Early Site Permit (ESP) Application for the Clinton ESP Site
Docket No. 52-007

Subject: Responses to Supplemental Draft Safety Evaluation Report (DSER) Items

Re: Letter, U.S. Nuclear Regulatory Commission (W. D. Beckner) to Exelon
Generation Company, LLC, (M. Kray), dated August 26, 2005,
Supplemental Draft Safety Evaluation Report for the Exelon Early Site
Permit Application

This letter provides response(s) to the following draft safety evaluation report (DSER) Supplement Open Items.

Figure 2.5.2-3-1
Loess Plasticity Chart

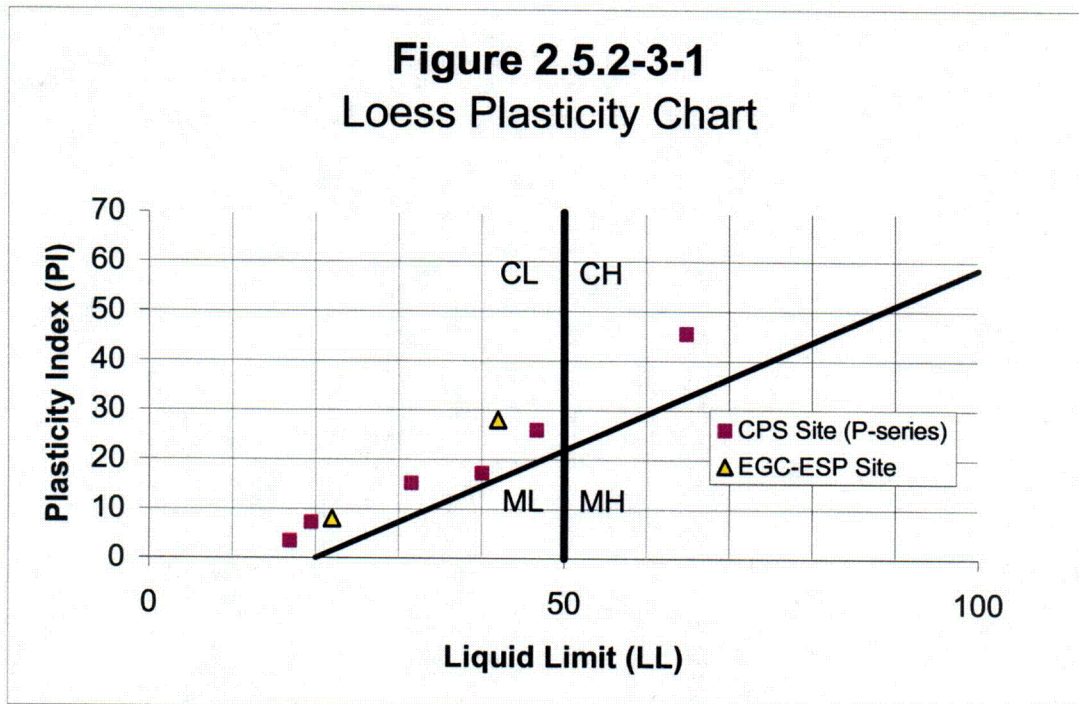
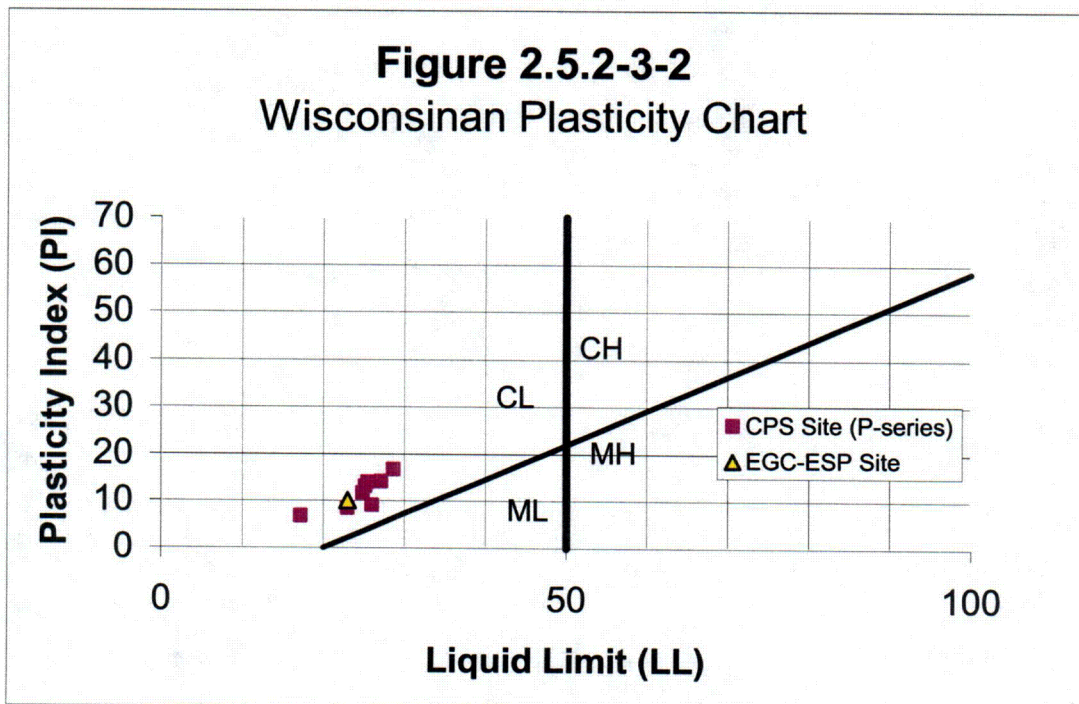
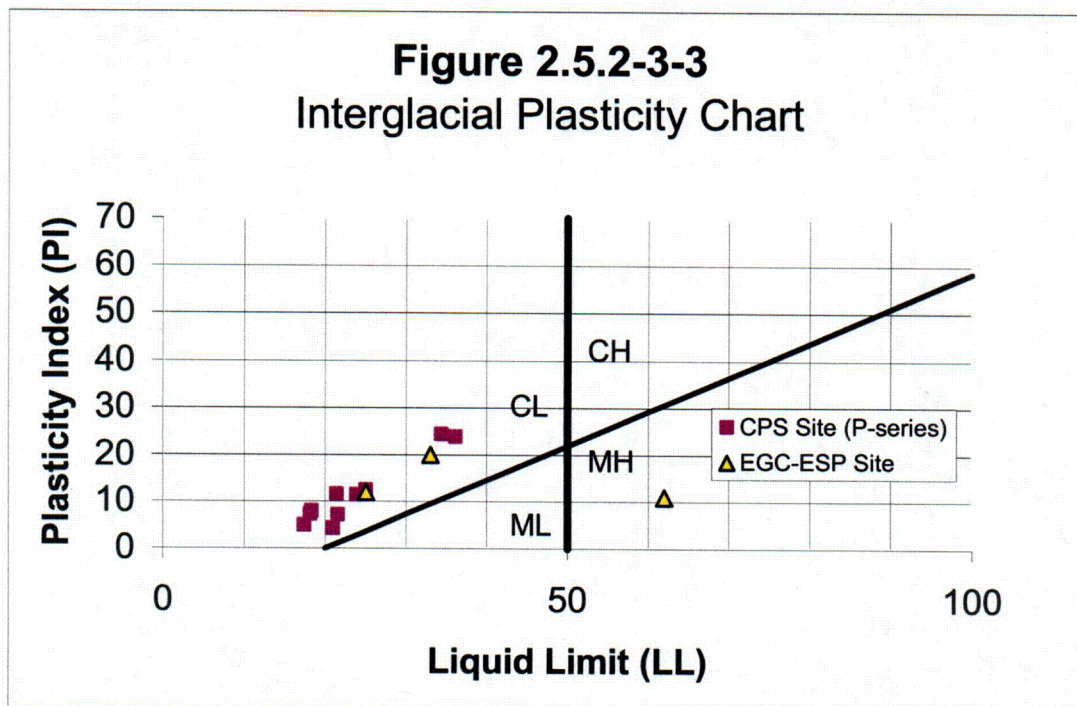
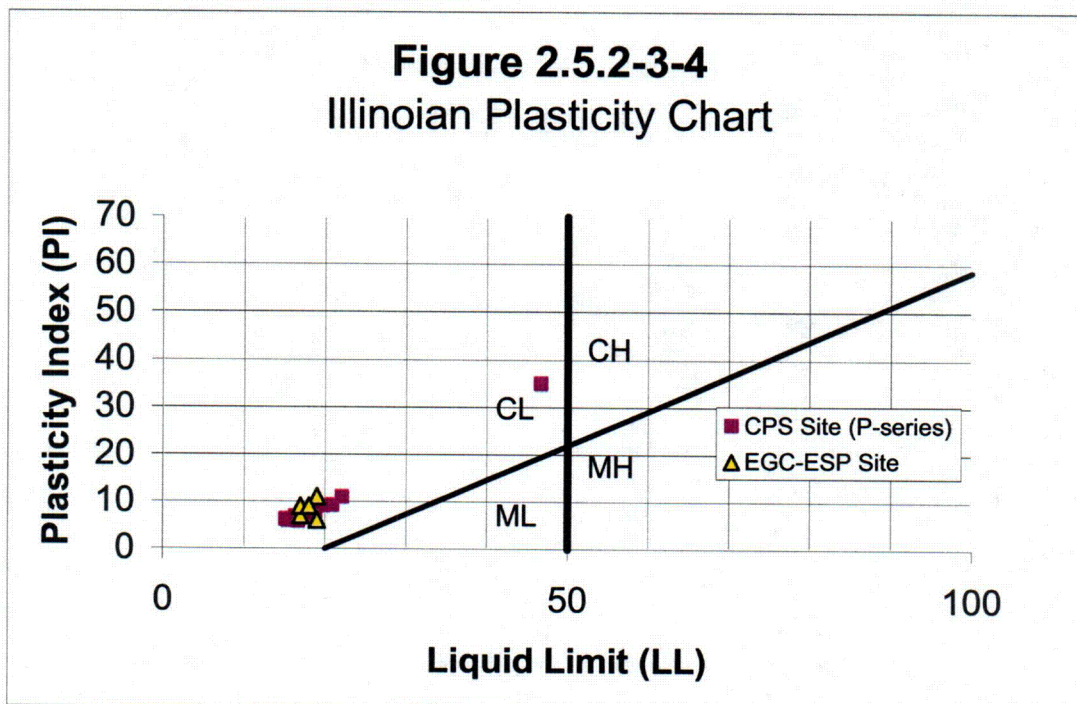
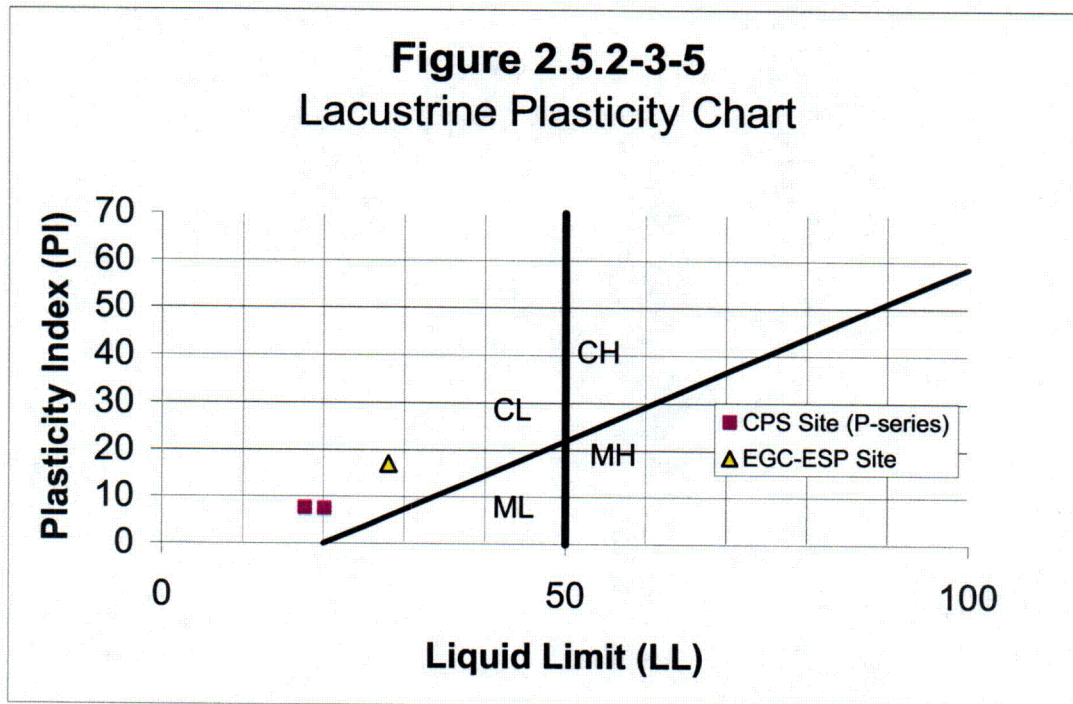
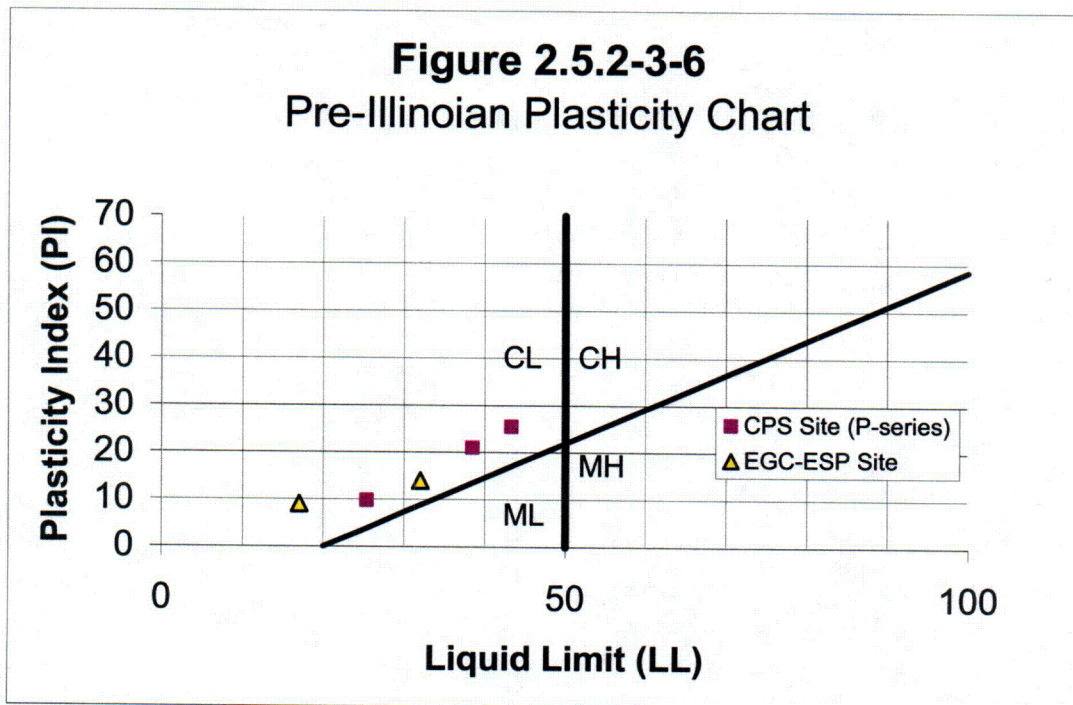
These plasticity plots are presented in Figures 2.5.2-3-1 through 2.5.2-3-6. The plots show that with the exception of one test result, the Atterberg limits tests on samples from the EGC ESP and the CPS Sites have a liquid limit of less than 50. Based on the Unified Soil Classification System (USCS), these soils are described as silts and clays with low plasticity. This description is consistent with that used for the EPRI standard modulus and damping curves.

Figure 2.5.2-4-3: Representative seismic sources used to assess earthquake frequencies and example hazard de-aggregation.

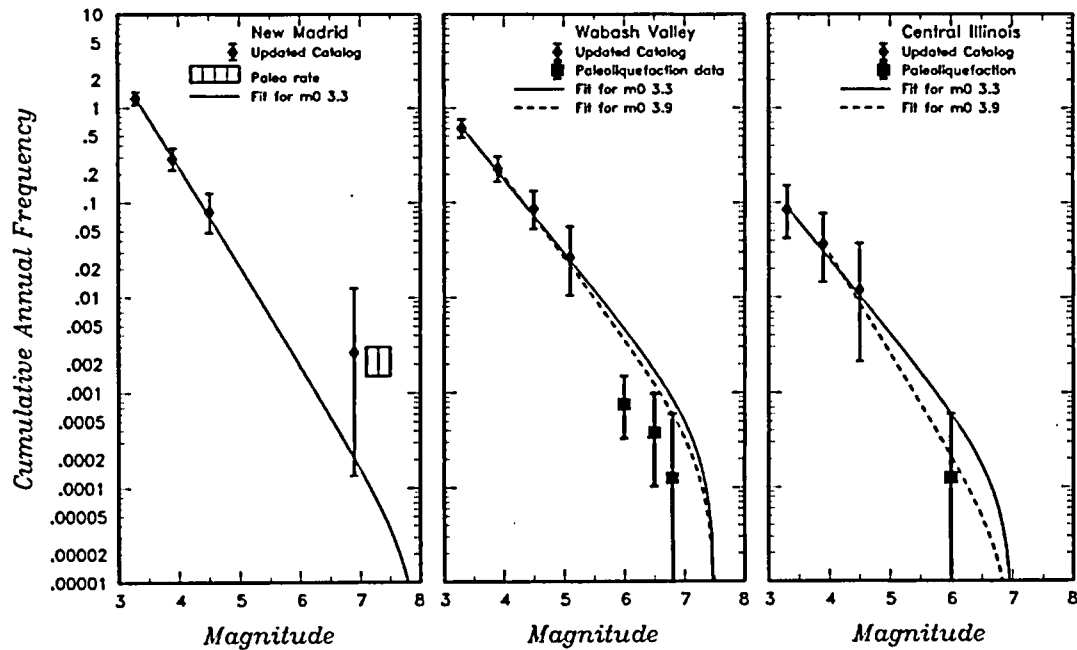
Figure 2.5.2-4-3 shows representative seismic sources used to assess the implications of the prehistoric earthquake data on earthquake occurrence rates. As discussed in Section 3.1.2 of Appendix B to the SSAR, earthquake frequencies within these sources computed using the earthquake catalog updated to include post EPRI-SOG seismicity are very similar to earthquake frequencies computed using just the EPRI-SOG (1988) catalog. Figure 2.5.2-4-4 compares the earthquake frequencies computed using the updated catalog with estimated earthquake frequencies for large earthquakes based on the prehistoric earthquake data. For the New Madrid sources, extrapolation of the earthquake frequencies based on recorded small magnitude seismicity under estimates the frequency of large earthquakes based on the 1811-1812 earthquakes and prehistoric earthquake sequences in approximately 900 AD and 1450 AD. As discussed in Section 4.1.1 of Appendix B to the SSAR, the EPRI-SOG seismic sources for New Madrid were modified to include a source of large magnitude earthquakes with an average repeat time of approximately 500 years in order to adequately represent the frequency of large earthquakes in the New Madrid region inferred from the paleoliquefaction data.

Figure 2.5.2-4-7: Example de-aggregation of the hazard from the central Illinois seismic source shown on Figure 2.5.2-4-3.

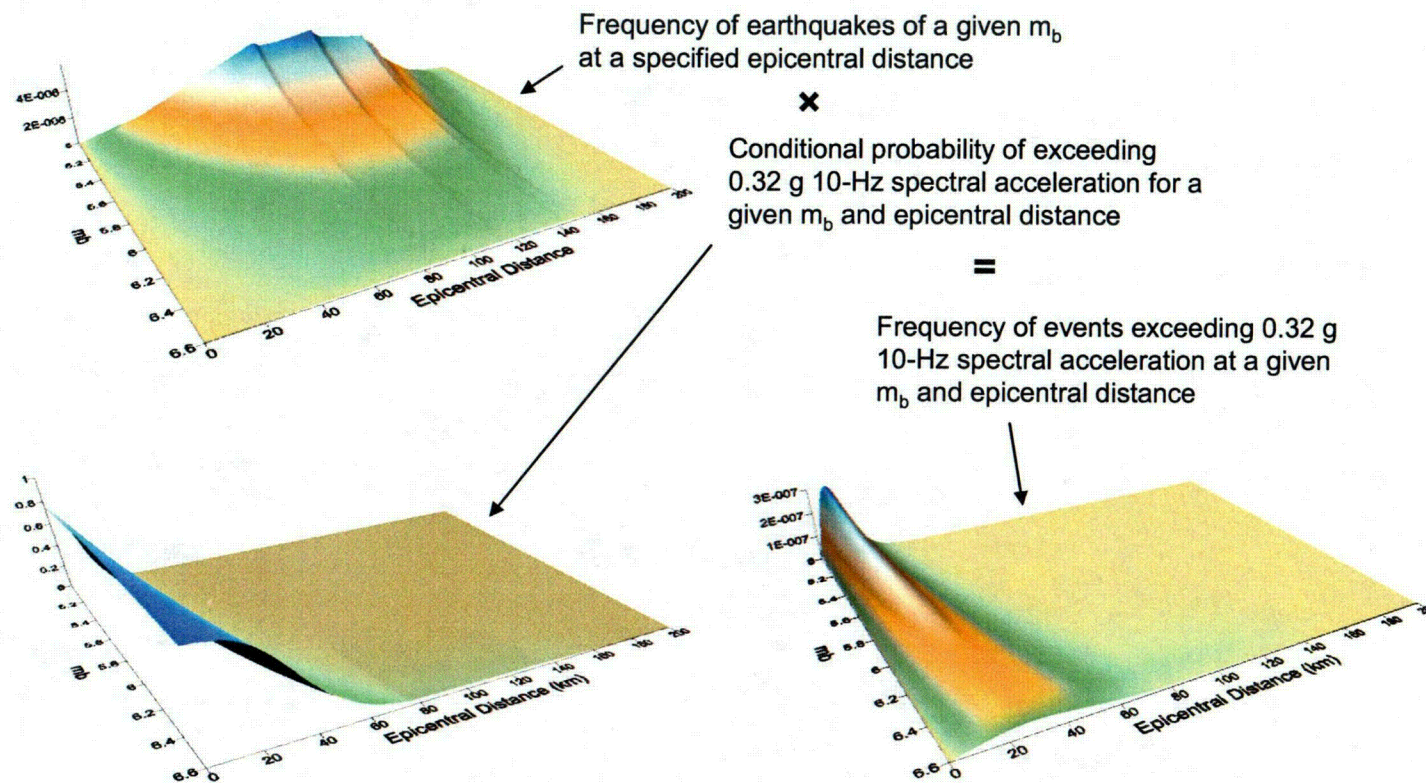
The lower left plot in Figure 2.5.2-4-7 shows the magnitude-distance distribution for the conditional probability of exceeding 0.32g 10-Hz spectral acceleration. This distribution was computed using the median model for Cluster 2 from the EPRI (2004) ground motion model. The 10-Hz spectral acceleration level of 0.32g is equal to the 10^{-4} exceedance frequency computed for the EGC ESP site. The conditional probability of exceedance decreases with increasing distance and increases with increasing magnitude – the opposite trend from that for the magnitude-distance de-aggregation of the earthquake occurrence rates.

The product of the earthquake occurrence rates and the conditional probability of exceedance is the frequency of exceedance (the hazard). The lower right plot in Figure 2.5.2-4-7 shows the magnitude-distance de-aggregation of the frequency of

Figure 2.5.2-4-8: Example de-aggregation of the composite hazard from the three example seismic sources shown on Figure 2.5.2-4-3.

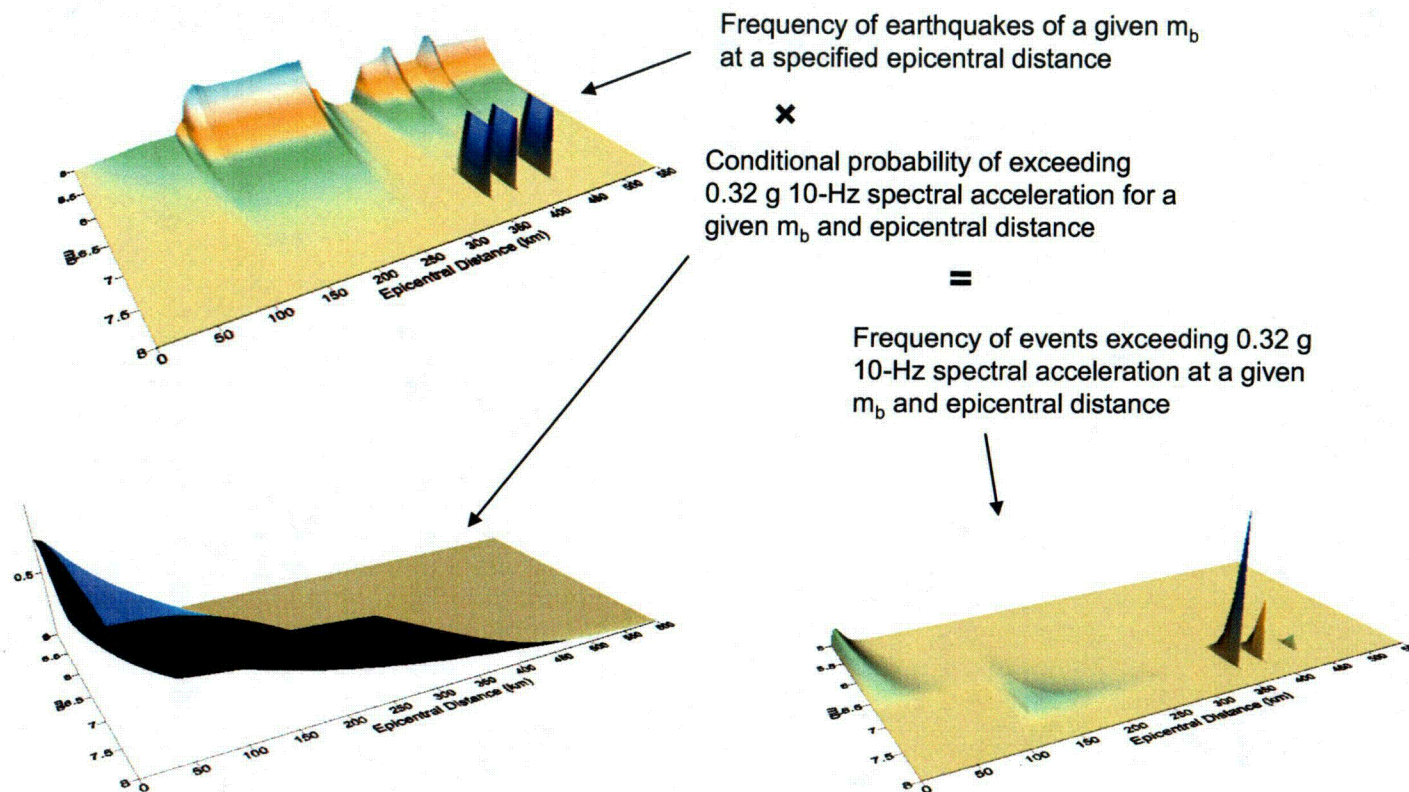
The de-aggregation of the hazard for the EGC ESP site reflects the contributions of the three groups of sources identified above. The example de-aggregation presented in Figure 2.5.2-4-7 was extended to include the contribution from all three of the example seismic sources shown on Figure 2.5.2-4-3. Figure 2.5.2-4-8 shows the composite magnitude-distance de-aggregations computed for these three sources. The top plot shows the de-aggregation of the combined earthquake frequencies. The higher seismicity in the New Madrid and Wabash Valley sources (Figures 2.5.2-4-1 and 2.5.2-4-4) produces large peaks in that magnitude-distance de-aggregation of earthquake frequencies at large distances from the site. The contribution from the central Illinois source now appears as a low level rise in the distance range of 0 to 100 km, reflecting the lower level of earthquake activity in central Illinois compared to the Wabash Valley and New Madrid regions. The three sharp large-magnitude peaks represent the three New Madrid fault sources with earthquakes occurring approximately every 500 years. The lower right plot of Figure 2.5.2-4-8 shows the magnitude-distance de-aggregation of the combined frequency of exceeding 0.32g 10-Hz spectral acceleration from all sources. The individual contributions of the three example sources can be seen in these results. The contribution from the central Illinois source appears at small magnitudes and small epicentral distances, as was seen in Figure 2.5.2-4-7. The contribution from the Wabash Valley source is indicated by the broad peak between distances of 100 and 200 km at larger magnitudes. Because of the large distance to the source, large magnitude earthquakes are the major contributor to the hazard from this source. The contribution from the New Madrid fault sources is again shown by the three sharp, large magnitude peaks between 350 and 450 km from the site.

Figure 2.5.2-5-1: SA (10 Hz) and SA (1 Hz) hazard curves for the eleven sites normalized by the acceleration value corresponding to mean 10^{-4} annual probability (From Figs. 7.7 and 7.8 of Ref. 4)

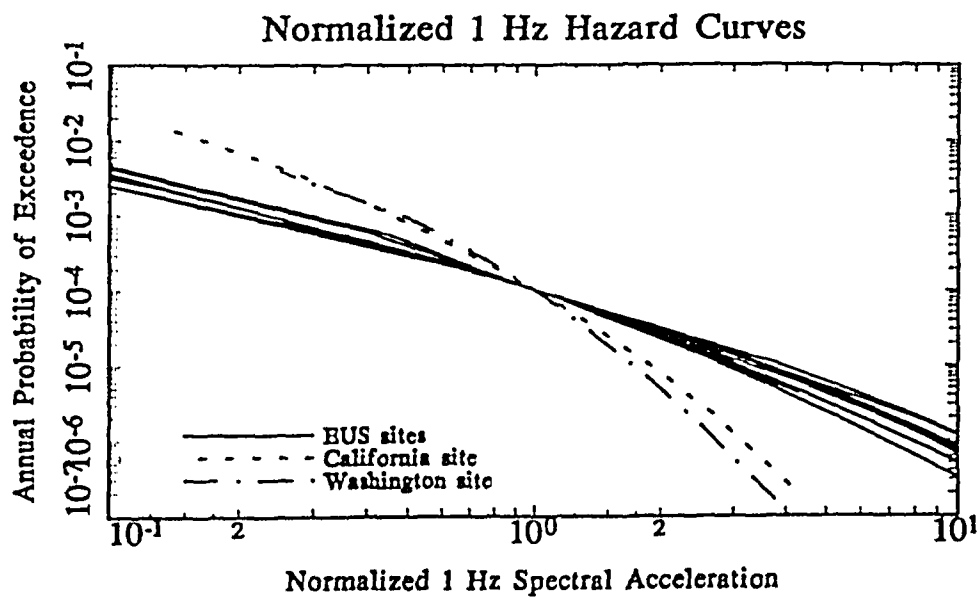
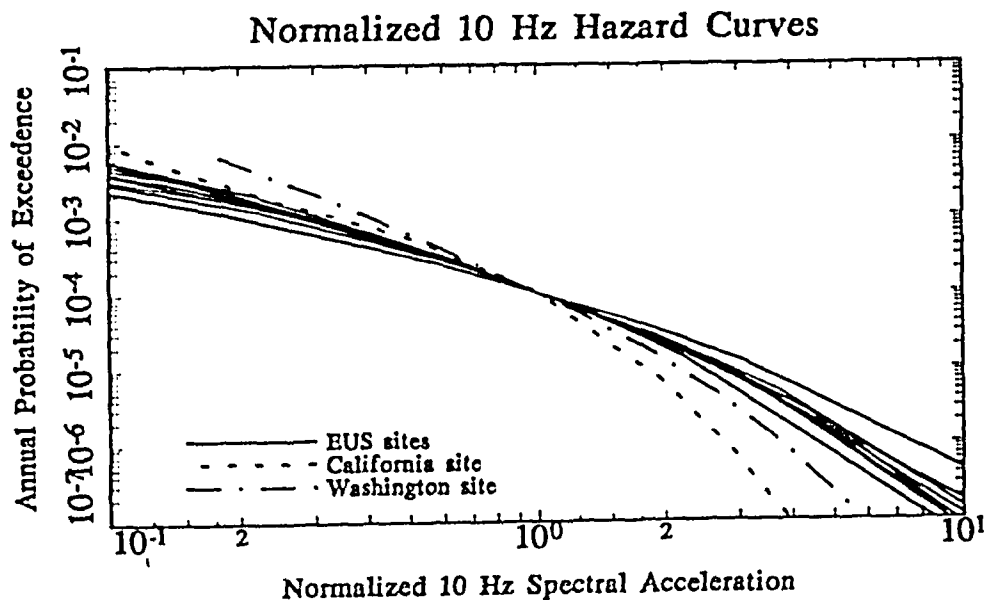
Figure 2.5.2-5-1 shows some representative normalized hazard curves taken from Figures 7.7 and 7.8 of NUREG/CR-6728 (Ref. 4). These hazard curves are all normalized to unity spectral acceleration at the reference hazard exceedance frequency $H = \text{mean } 1 \times 10^{-4}/\text{yr}$ for ease of visualizing the differences in hazard curve slopes. Table 2.5.2-5-2 presents the tabulated normalized spectral acceleration values SA at 1 Hz and 10 Hz for one Eastern U.S. hazard curve and for the California hazard curve.

The approximate power-law hazard curves are defined by Equations (2.1) and (2.2) with A_R defined by Equation (1.4). These approximate hazard curves would appear as a straight line on the log-log plots of Figure 2.5.2-5-1 with the amplitude and slope defined by the spectral accelerations at $1 \times 10^{-4}/\text{yr}$ and $1 \times 10^{-5}/\text{yr}$ hazard exceedance frequencies. However, all actual seismic hazard curves have a downward curvature similar to those

shown in Figure 2.5.2-5-1 when plotted on log-log plots. The intent of this example is to study the effect of this downward curvature on the P_{FC} computed by rigorous numerical convolution versus the P_{FC} computed using the approximate power law hazard curve.
